**Administrative Committee of the European Agreement
Concerning the International Carriage of Dangerous
Goods by Inland Waterways (ADN)**

Draft amendments to the Regulations annexed to ADN*

At its twenty-fourth session (31 January 2020), the ADN Administrative Committee requested the secretariat to prepare a consolidated list of all the amendments it had adopted for entry into force on 1 January 2021 so that they could be made the subject of an official proposal in accordance with the procedure set out in article 20 of ADN. The notification would have to be issued no later than 1 July 2020, with a reference to 1 January 2021 as the scheduled date of entry into force (see ECE/ADN/53, paragraph 22).

1.2.1 In the definition of *Classification of zones*, amend the fifth indent of the paragraph “**Zone 1** comprises” to read as follows:

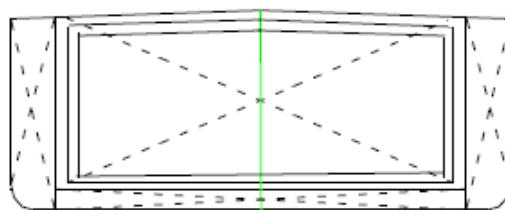
“Every opening in zone 0 except the high velocity vent valves/safety valves of pressurized cargo tanks shall be surrounded by a cylindrical ring whose inner radius is that of the opening, the outer radius is equal to that of the opening plus 2.50 m and the height is 2.50 m above the deck and 1.50 m above the piping.

For openings with a diameter of less than 0.026 m (1”), the distance to the outer cofferdam bulkhead may be reduced to 0.50 m, provided it is ensured that such an opening is not opened to the atmosphere within this distance;”
